Addendum #2 – November 4, 2020

2020.11.04-PSD7Schools_FireAlarmReplacement_Add2_Plans (10 pages)

ISSUES & REVISIONS:		
NO.: 1	DATE: 11/04/2020	BY: TGS
DESCRIPTION: ADDENDUM 2		
NO.:	DATE:	BY:
DESCRIPTION:		
NO.:	DATE:	BY:
DESCRIPTION:

PROJECT:
FORT COLLINS HIGH SCHOOL
3400 LAMBKIN WAY,
FORT COLLINS, CO 80525

SHEET NAME:
FC.FA101H

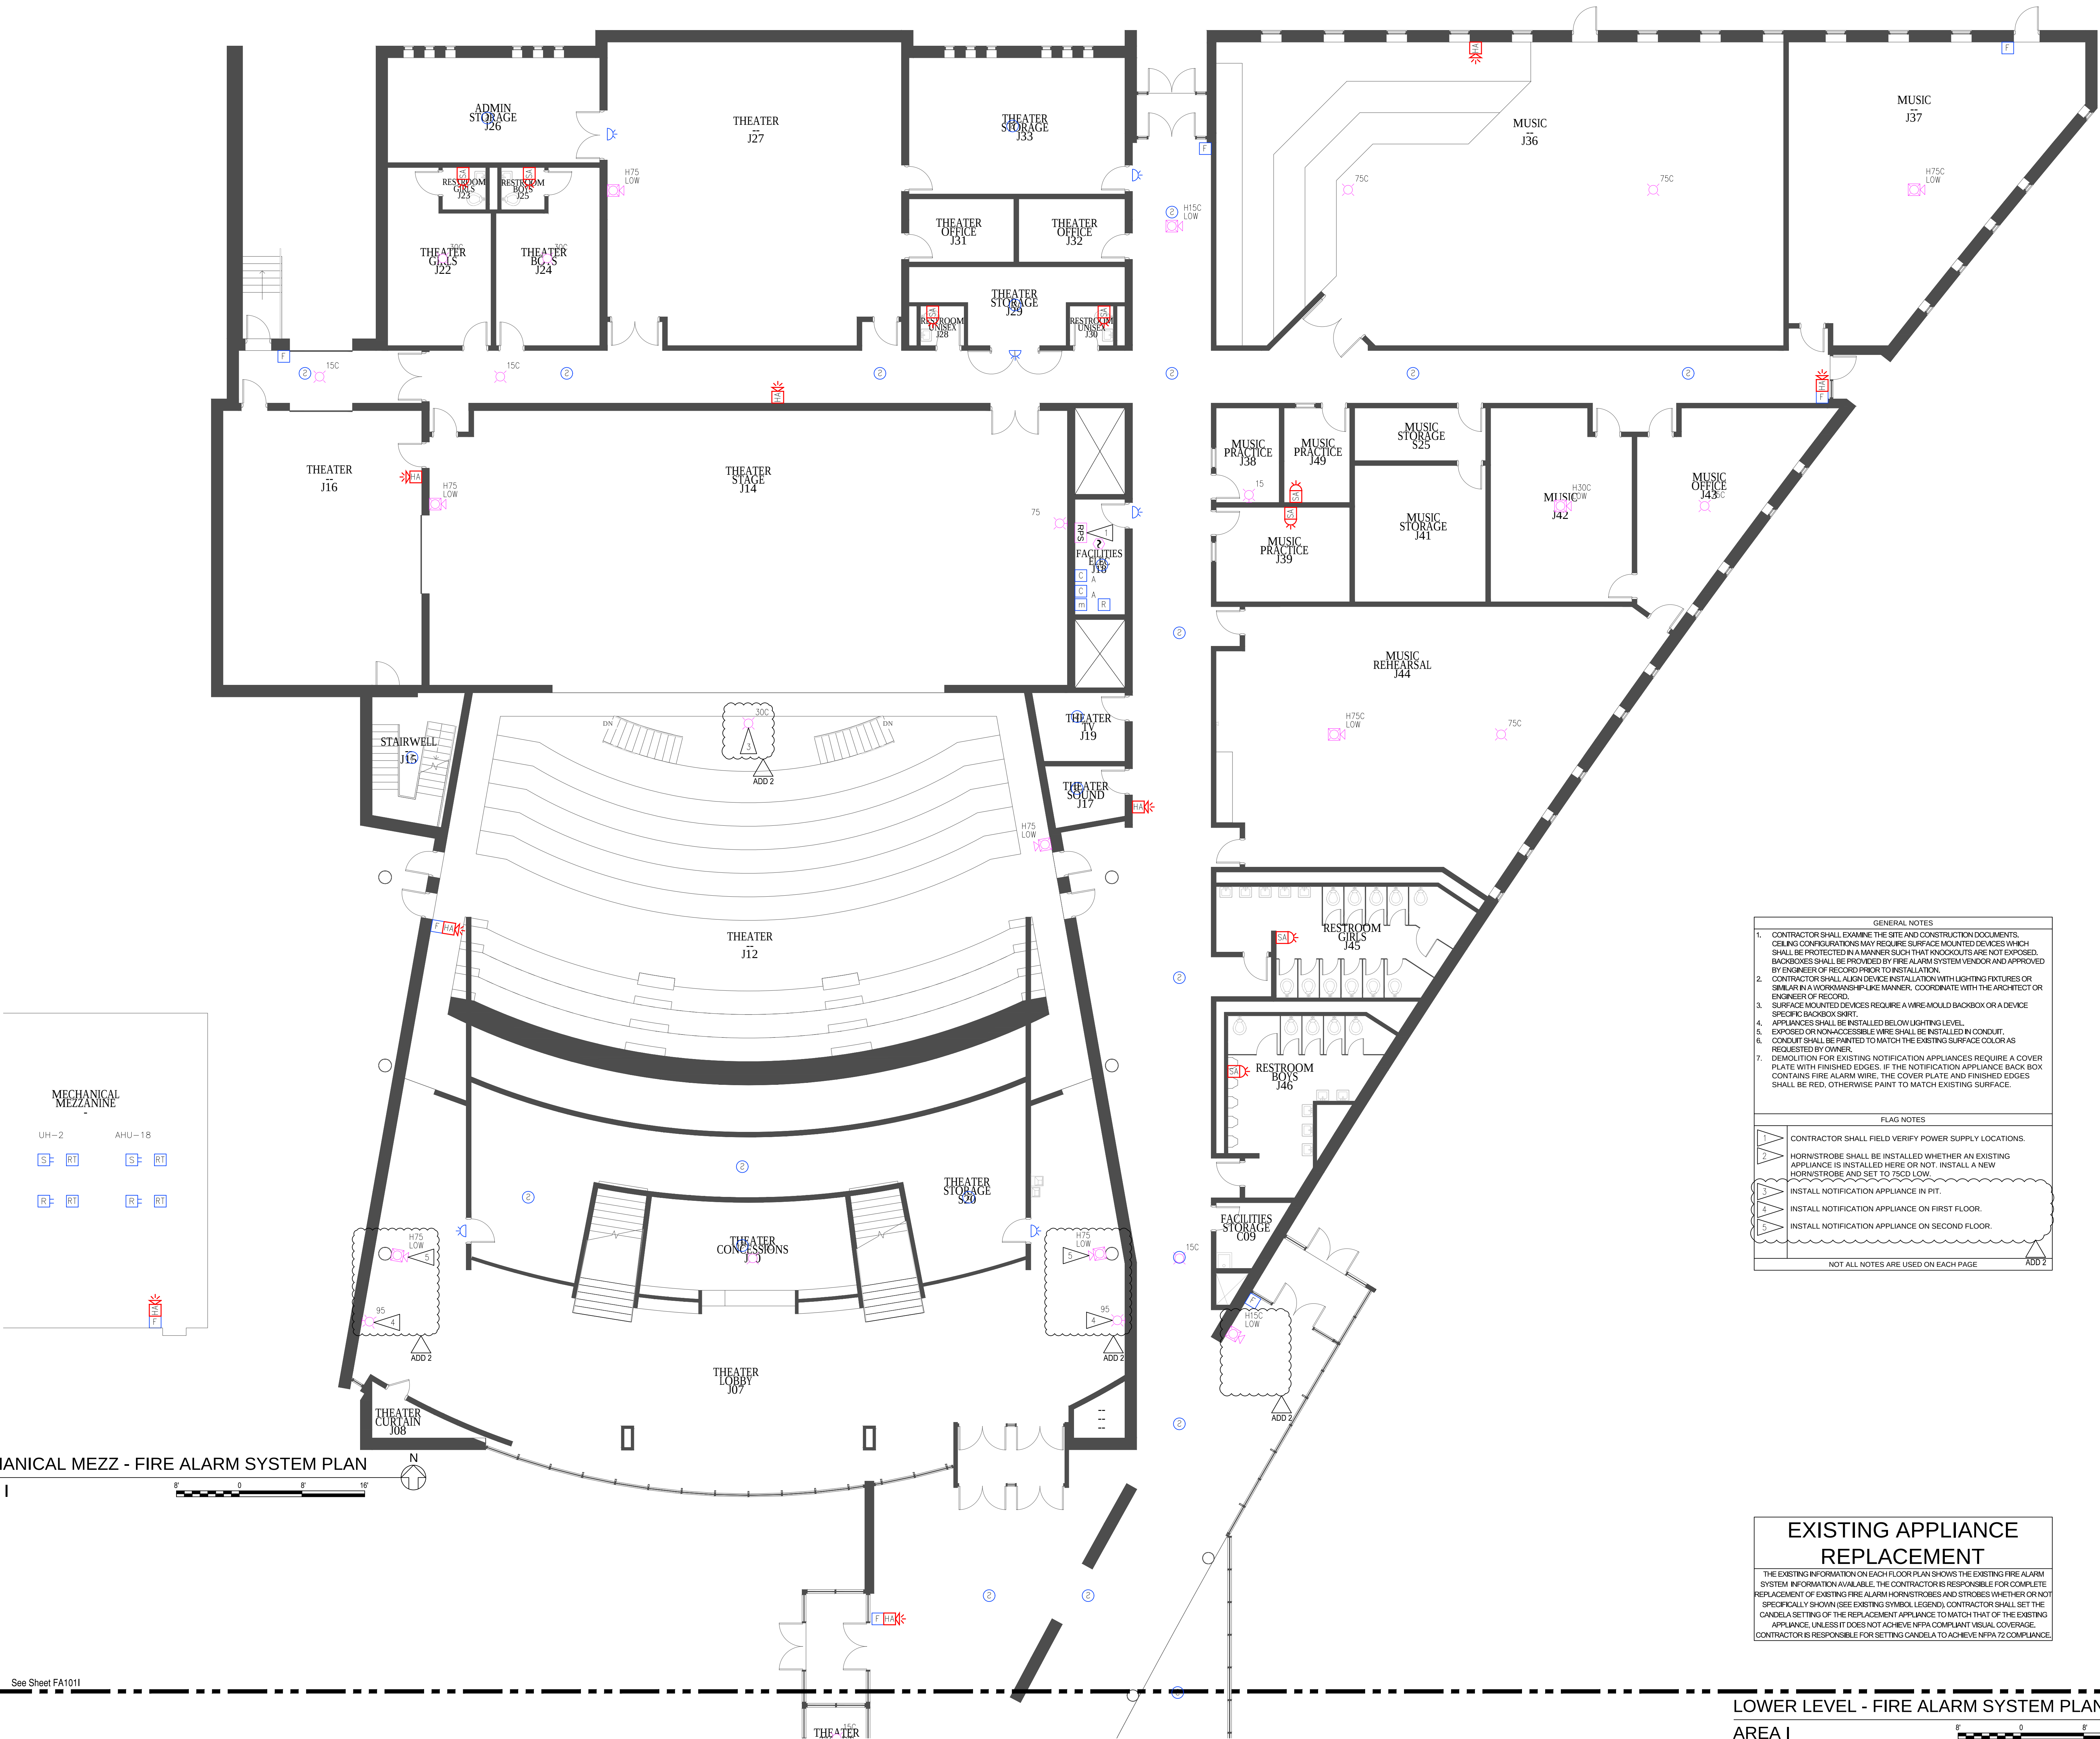
1. Relocate horn/strobe appliances in the main corridor from ceiling mount to wall mount.

SHEET NAME:
FC.FA101I

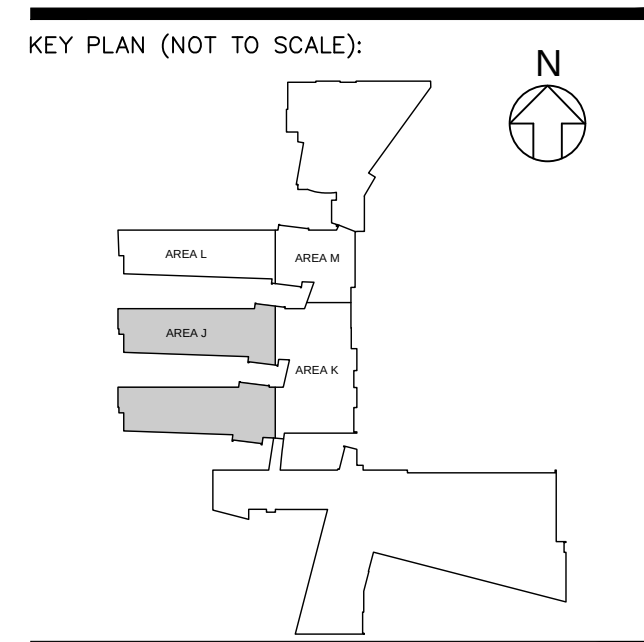
1. Relocate horn/strobe appliances in the main corridor from ceiling mount to wall mount.
2. Add strobe to the pit with flag note 3 "Install notification appliance in pit."
3. Add 95cd wall mounted strobes to the first floor Theatre Lobby J07 with flag note 4 "Install notification appliance on first floor."
4. Add flag note to wall mounted horn/strobes on the second floor near Theatre Lobby J07 with flag notes 5 "Install notification appliance on second floor."
